Project: IEEE P802.15 Working Group for Wireless Personal Area Networks (WPANs)

Submission Title: Comment Resolution LB-95

Date Submitted: December 5, 2014

Purpose: Comment Resolution for comments collected from LB-95

FIGURE 5.3–6

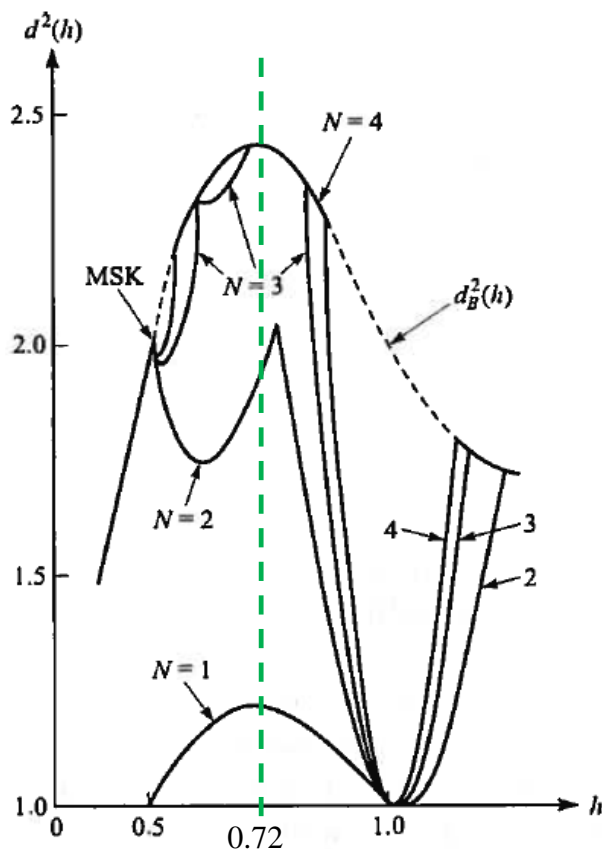
Comment: Without loss of generality the following for the 863-876 and 915-921 bands:

1st Channel Center Freq.: 863.25, 915.35

Number of Channels: 63, 27 Channel Spacing: 200,000, 200,000

Modulation Scheme: GFSK, GFSK FSK Mod. Order: 2, 2

FSK Mod. Index: 0.7, 0.7 FSK BT: 0.5, 0.5 Symbol Rate: 100,000, 100,000

provide nearly the same number of channels while providing/allowing for an an improvement in nearly all receiver performance parameters.

Proposed change: Consider these changes for the 863-876, 915-921 and apply similarly for all other bands.

Lowering the mod-index from 1 to 0.7 as suggested in Comment ID 1151 increases the Euclidean distance \rightarrow lowers E_b/N_0 in receiver \rightarrow increases link budget. See figure below:

Resolution: (1151, 1171 and 1003): replace 400/800kbps with 500/1000kbps and reduce modulation index of MCS 0, 1, 2, 3, 4, 0a, 1a, 2a, 3a and 4a by 28%

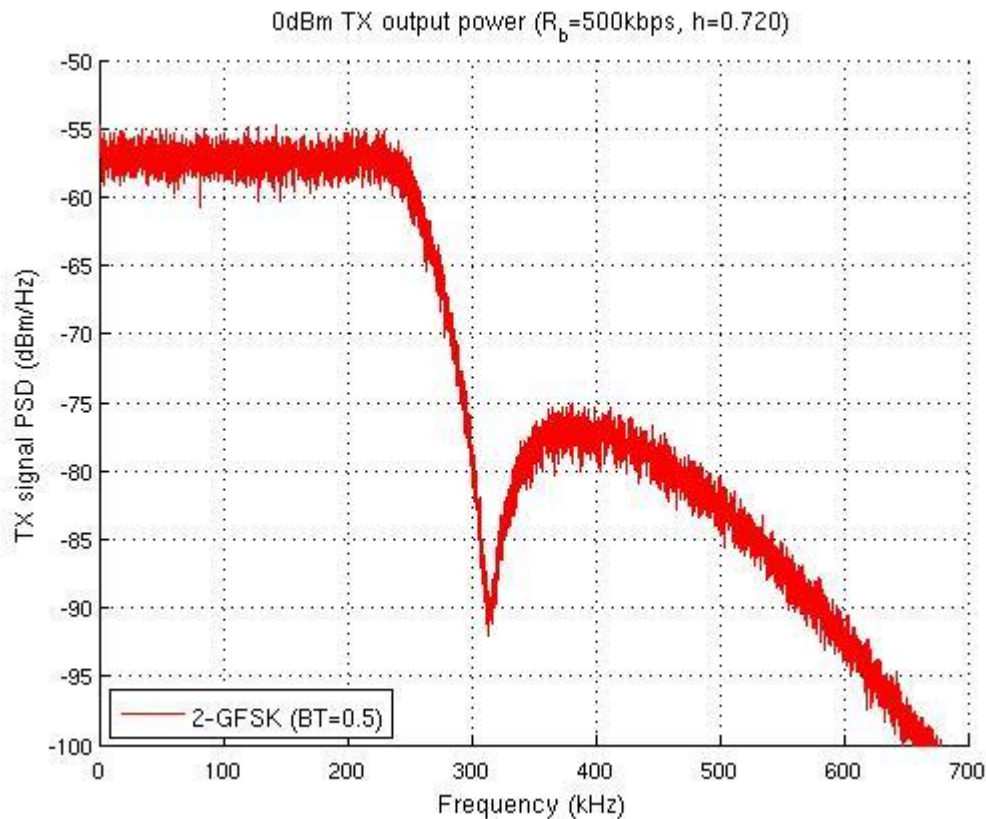
Comment: A MCS should be added to Table 21 to support FCC digital modulation according to FCC part 15 clause 247. This provides an option to increase the RF transmit power without frequency hopping.

Proposed change: Add MCS with identifier 9: Data Rate = 500kbps, Channel spacing = 1MHz, modulation index = 0.75. This results in a flat spectrum suitable to meet the FCC requirements for wideband digital modulation. Also add identifier 9 in Table 23 in the 915 and 2450 MHz rows.

Modulation parameters:

- Data Rate = 500kbps, BT= 0.5, Channel spacing = 1MHz, mod-index = 0.72.
- Spectrum optimally flat at mod-index = 0.72:

- Add sentence below table 22: “MCS 4 may be used for wideband digital modulation according to FCC part 15.247 which allows for transmit power in excess of -1.23 dBm without requiring frequency hopping”
- Note: MCS numbers are changed according to the resolution of comment ID 1003.

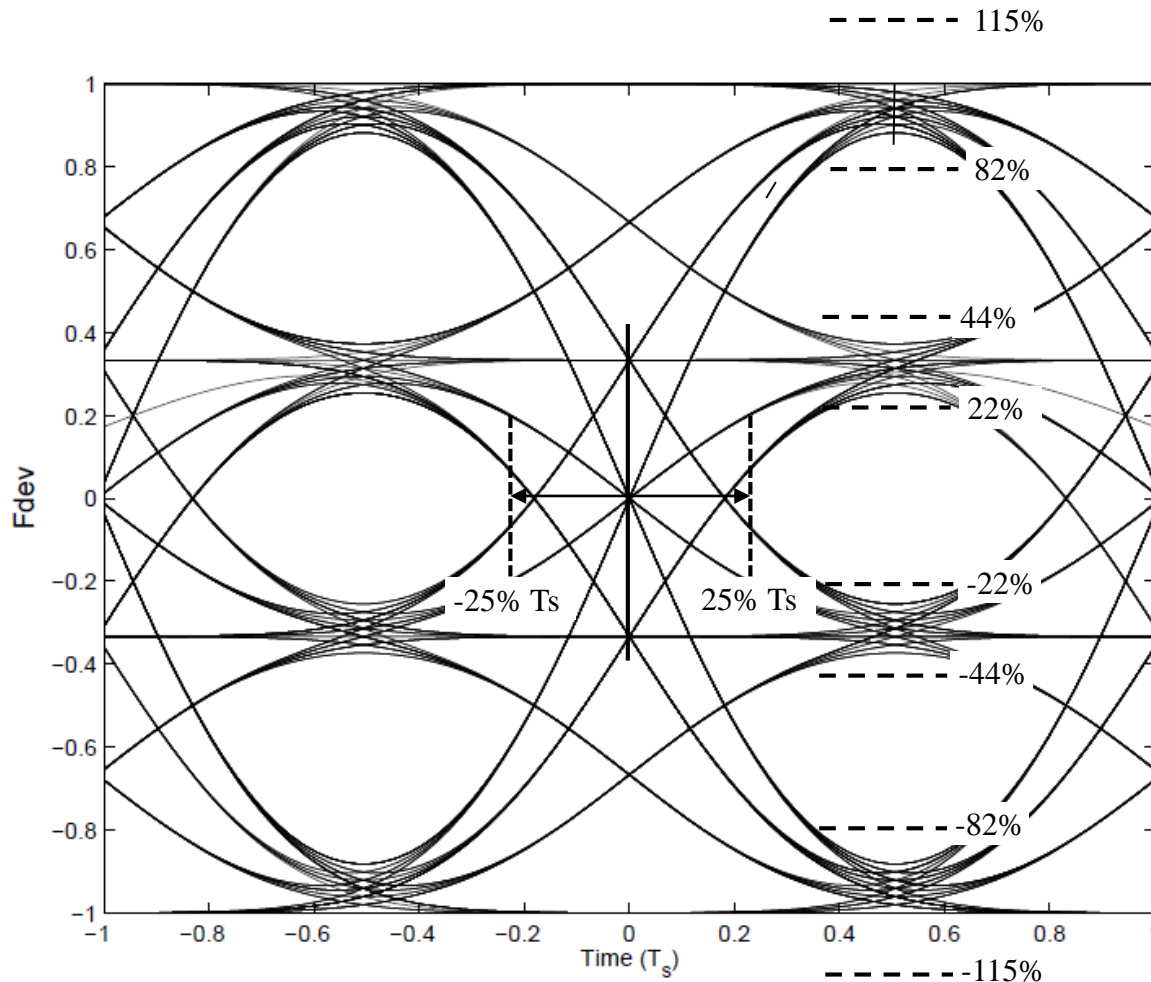
Comment: The frequency deviation tolerances are too course. Will degrade the receive sensitivity.

Proposed change: Reduce the deviation tolerance.

Resolution : Accepted in principle. Add new figure below to sub clause 31.2.5. with title: “Eye diagram of 4GFSK modulation”

Replace sentence "The frequency deviation tolerance shall be as given in 18.1.2.3.1" by "The frequency deviation tolerance for 2-GFSK shall be as given in 18.1.2.3.1. The frequency deviation tolerance for 4-GFSK shall be as given in Figure xx"
